AGENDA

Town Planning & Building Committee

Tuesday, 6 November 2018 at 6.30pm

This report considers a planning application for additions and alterations, including a garage and upper storey to the existing grouped dwelling at No. 27A Duke Street, East Fremantle.

PROPOSED ALTERATIONS + ADDITIONS 107 288 N7 WOODHOUSE ROAD, EAST FREMANTLE.
 FOR ST. CHARLES WORTH BY EVISION HOMES. © TRW:MR. 1:100 A2 060818 DRG 30/B

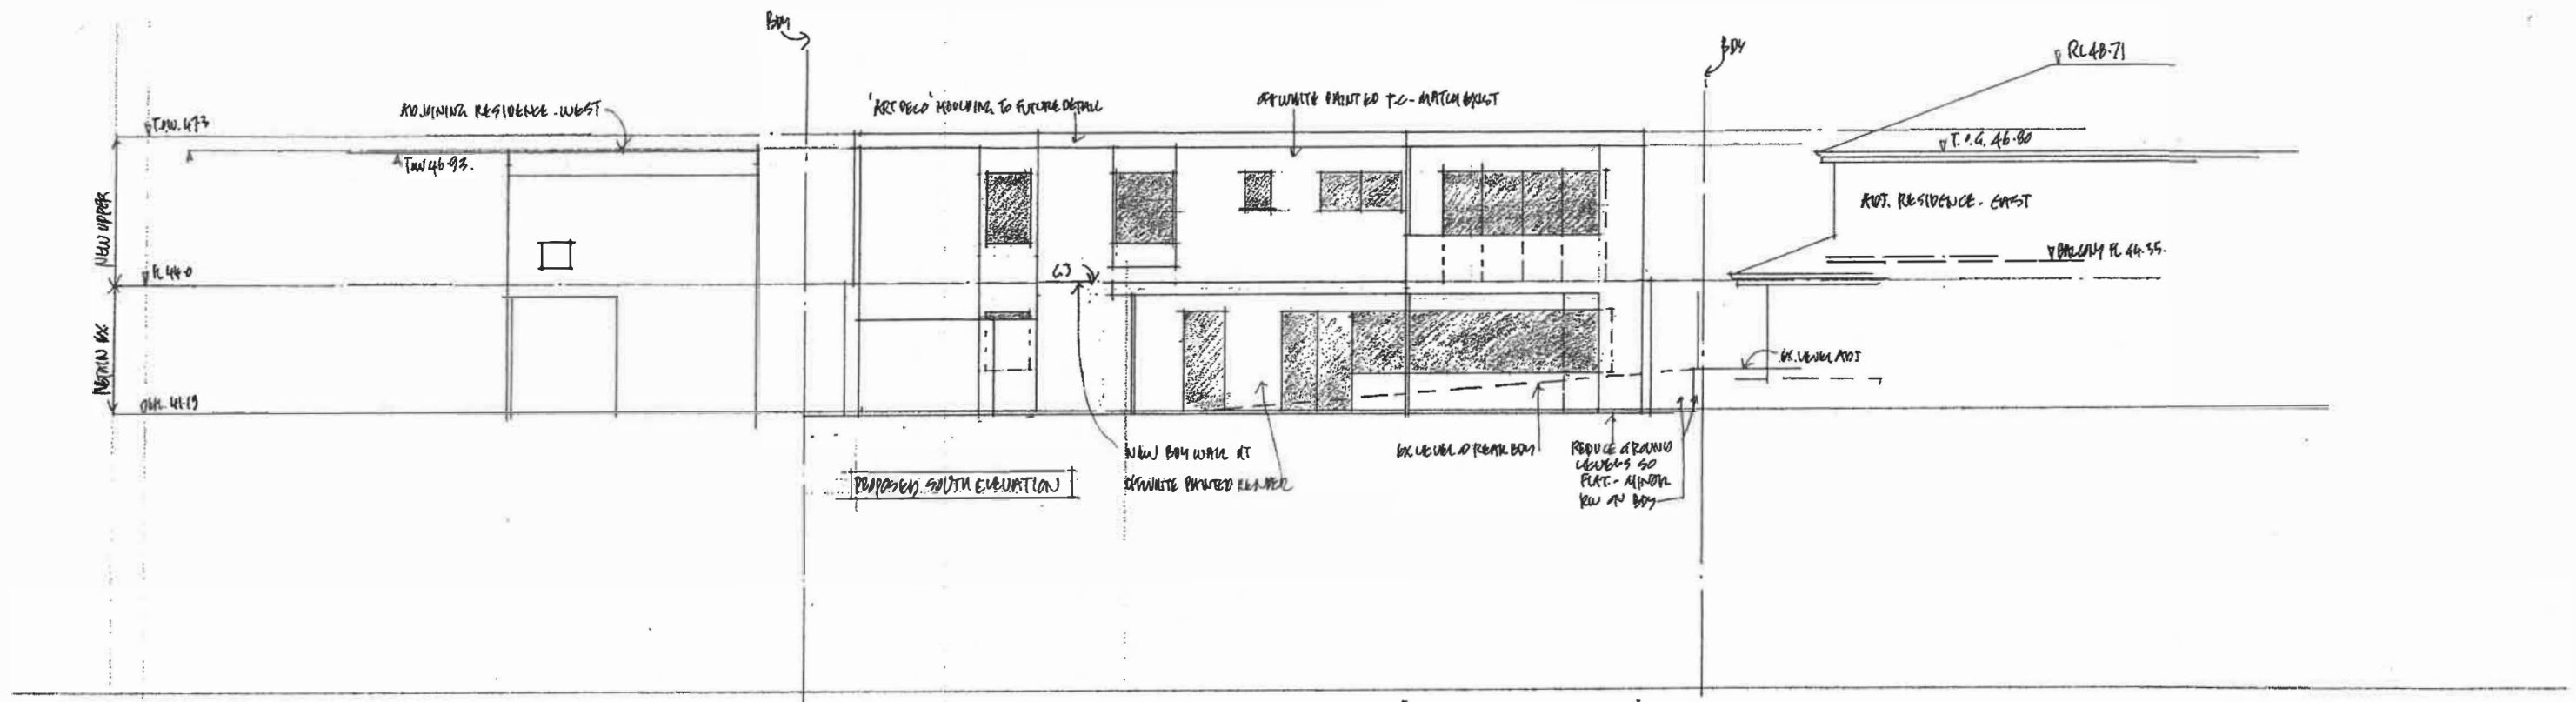
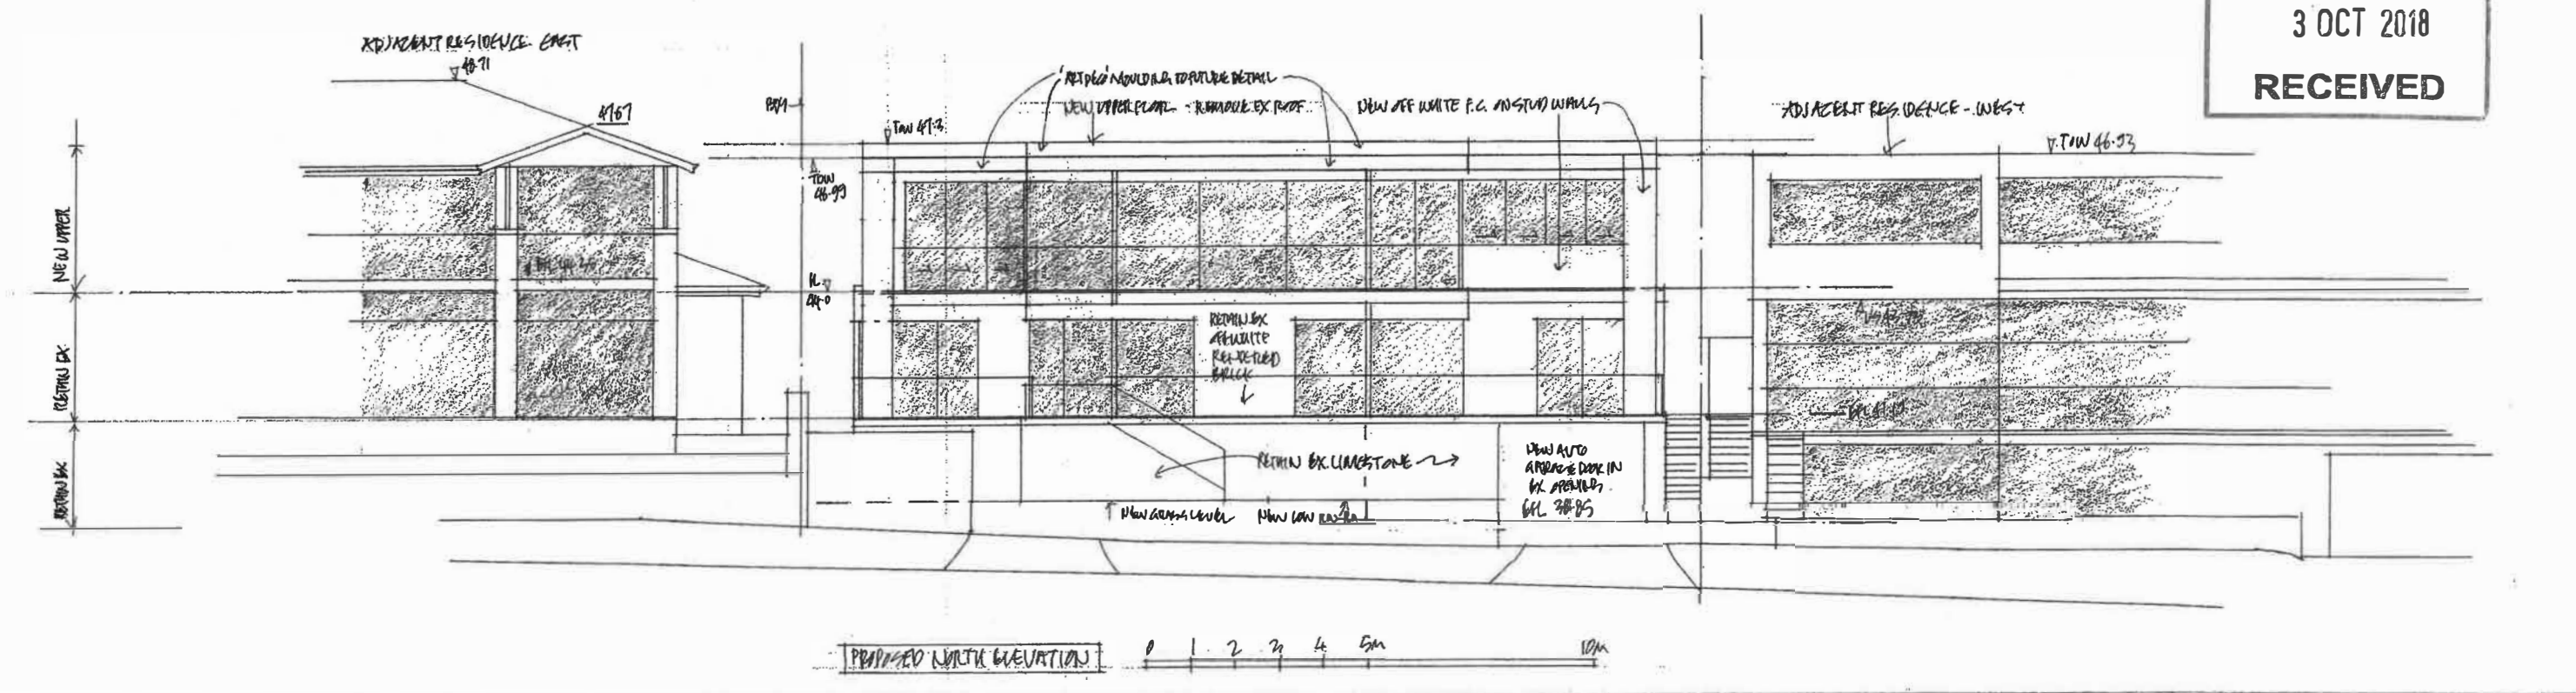
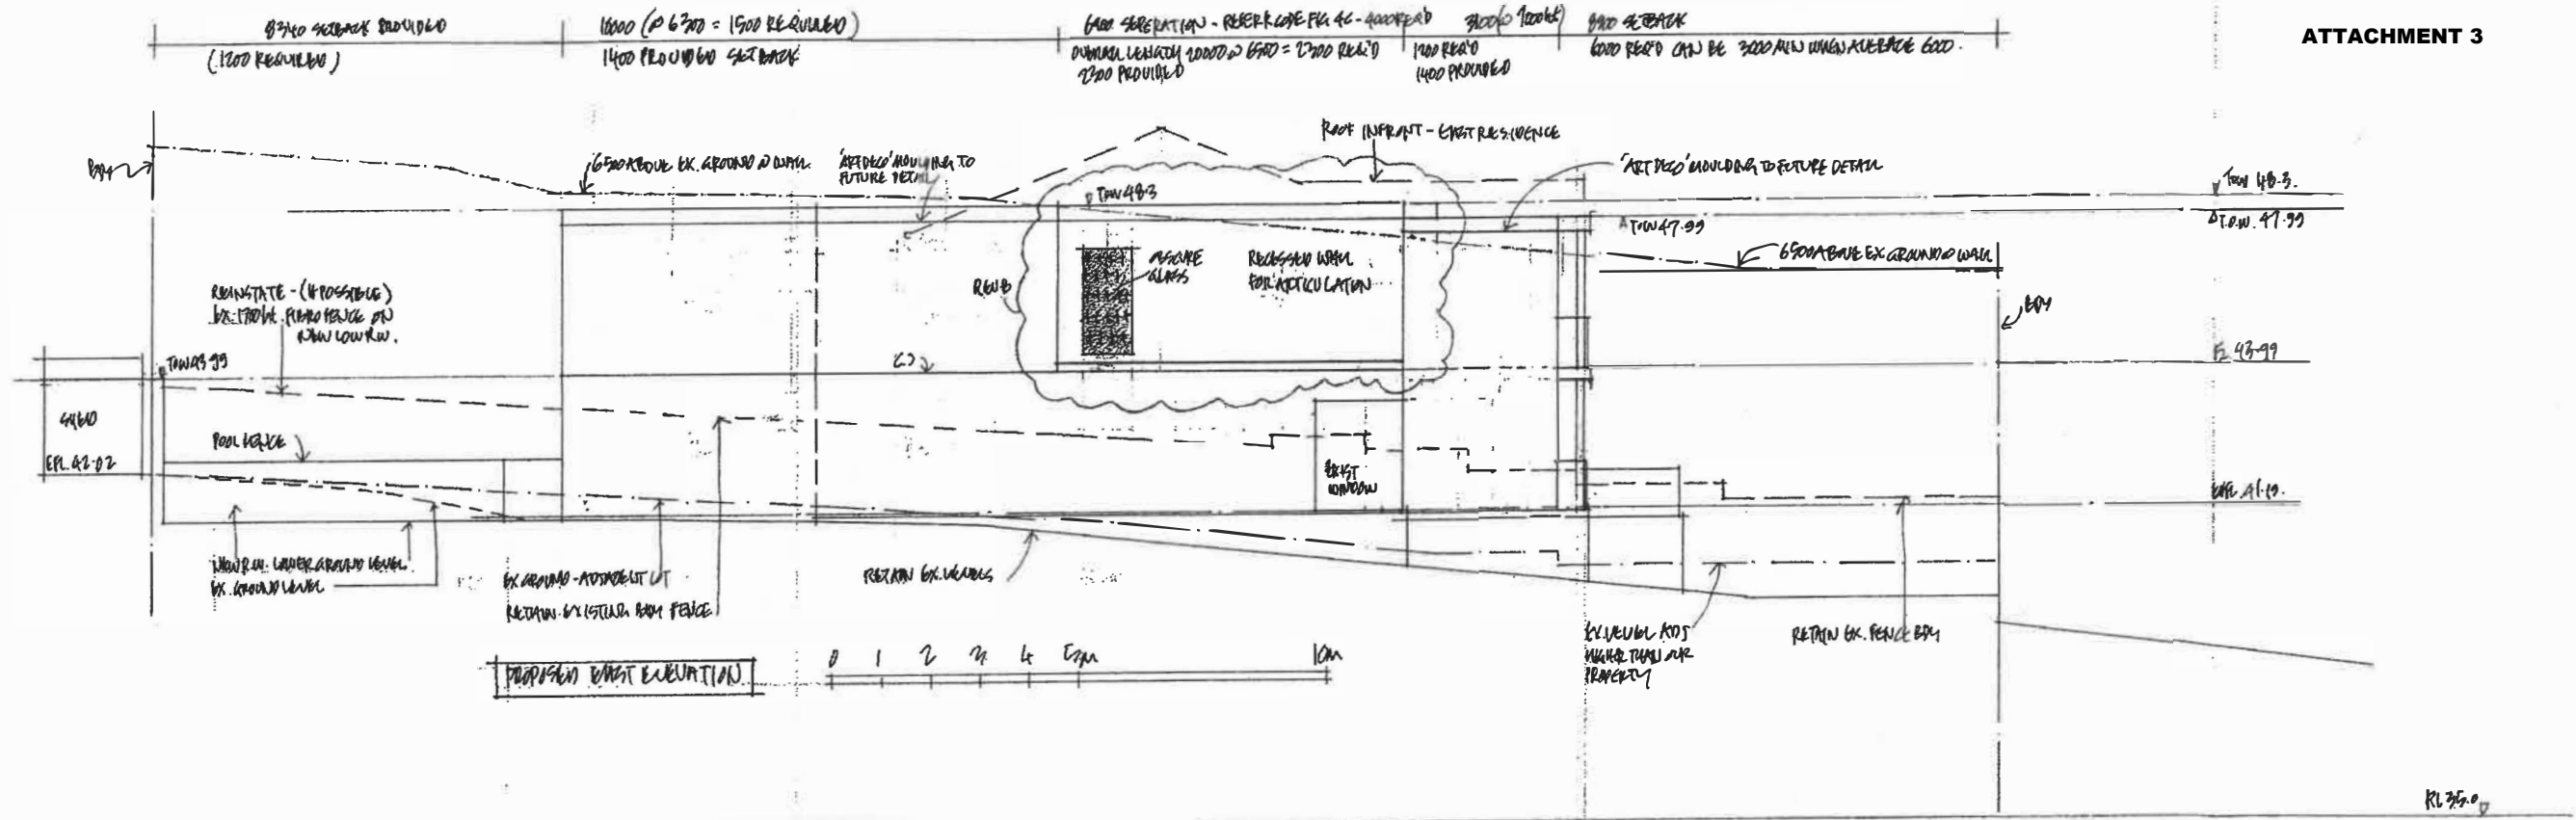
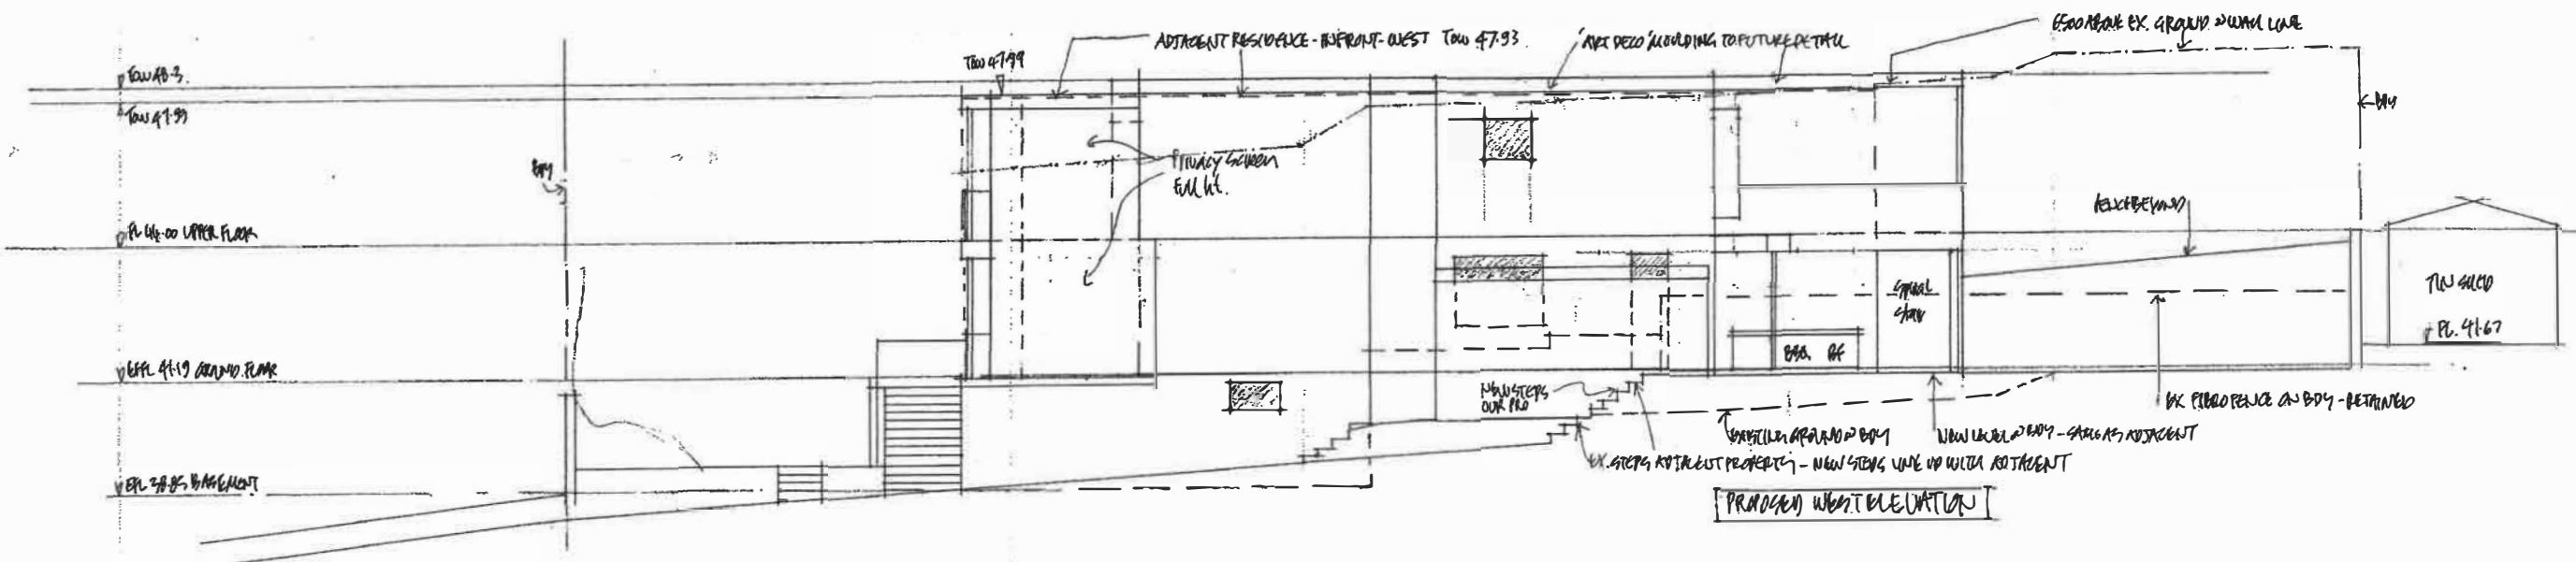
The set of plans available for review are hand drawn and not very well detailed. There is no finishes schedule made available for review, nor a landscaping plan.

We have concerns over the proposed pool to the rear of the property, and how it will be constructed. There is no detail as to the engineering of the design. The excavation angle of repose would potentially damage our property.

The existing dwelling is a fine example of art deco architecture, with curved glass frontage and pitched roof. Whilst there is no heritage listing on the existing dwelling, we note that the proposed additions do not seem to be keeping with the existing style of architecture – as required by the Local Planning Policy.

As per State Planning Policy 3.1 and the Town of East Fremantle Residential Design Guidelines, the side setbacks are not compliant.

Should the second storey addition be set back in accordance with the local and State planning policy, we suggest that this will reduce the detrimental impact on our amenity.

- (a) *The overall built form merits;*
- The Committee consider the plans do not provide sufficient information to be able to make an assessment of the application. Details and materials on the plans are lacking.

- The Committee consider the quality of architectural design is difficult to determine as there is insufficient detail and information to be able to undertake an assessment.

As noted in detail in Attachment 4 the applicant believes the set of plans provides all the required information and are drawn to scale. External wall finishes and colours are noted and the extent of all landscaping, retaining walls and levels are provided.

For the purposes of the planning assessment no further detail or amended plans are required.

SITE SURVEY PLAN
SCALE 1:100

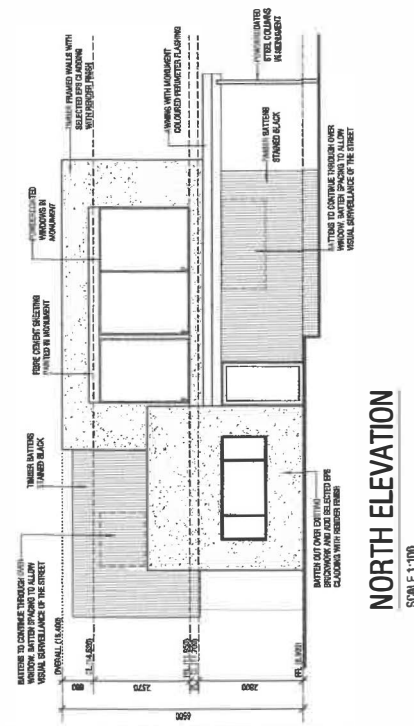
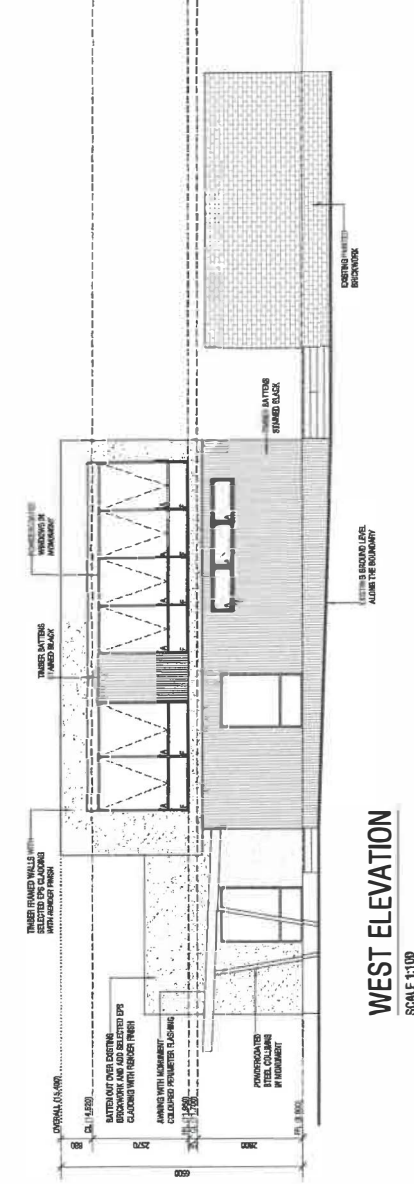
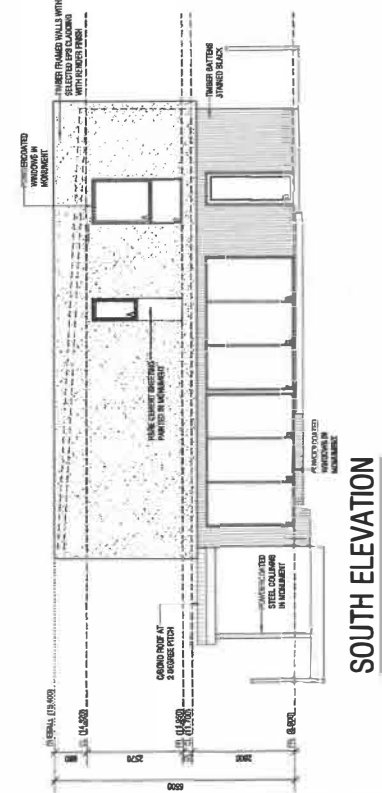
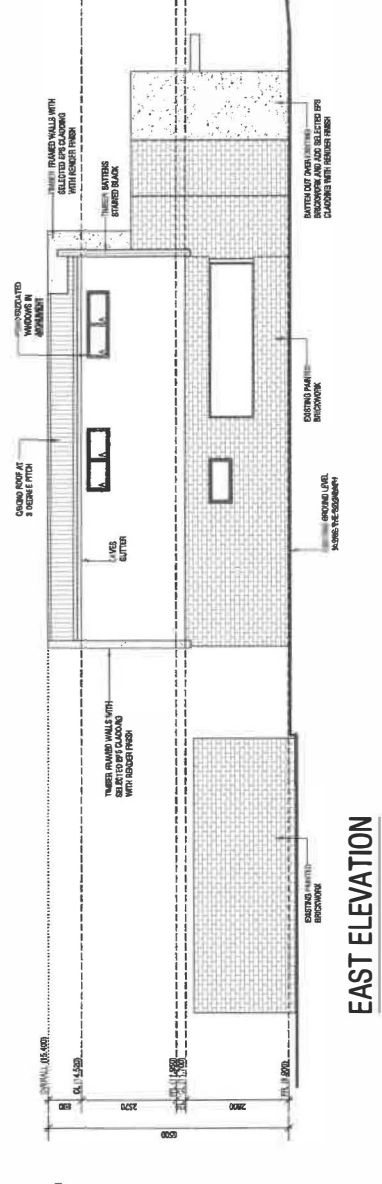
“(3) All major openings to lower (subject to the height of the boundary fence not reaching 1.6 metres above the altered ground level) and upper floor habitable rooms on the eastern and western elevations where the visual privacy setback of the R-Codes is not met to comply with clause 5.4.1 C1.2 of the Residential Design Codes of WA and indicated on the Building Permit application plans to the satisfaction of the Chief Executive Officer and installed prior to occupation of the dwelling.
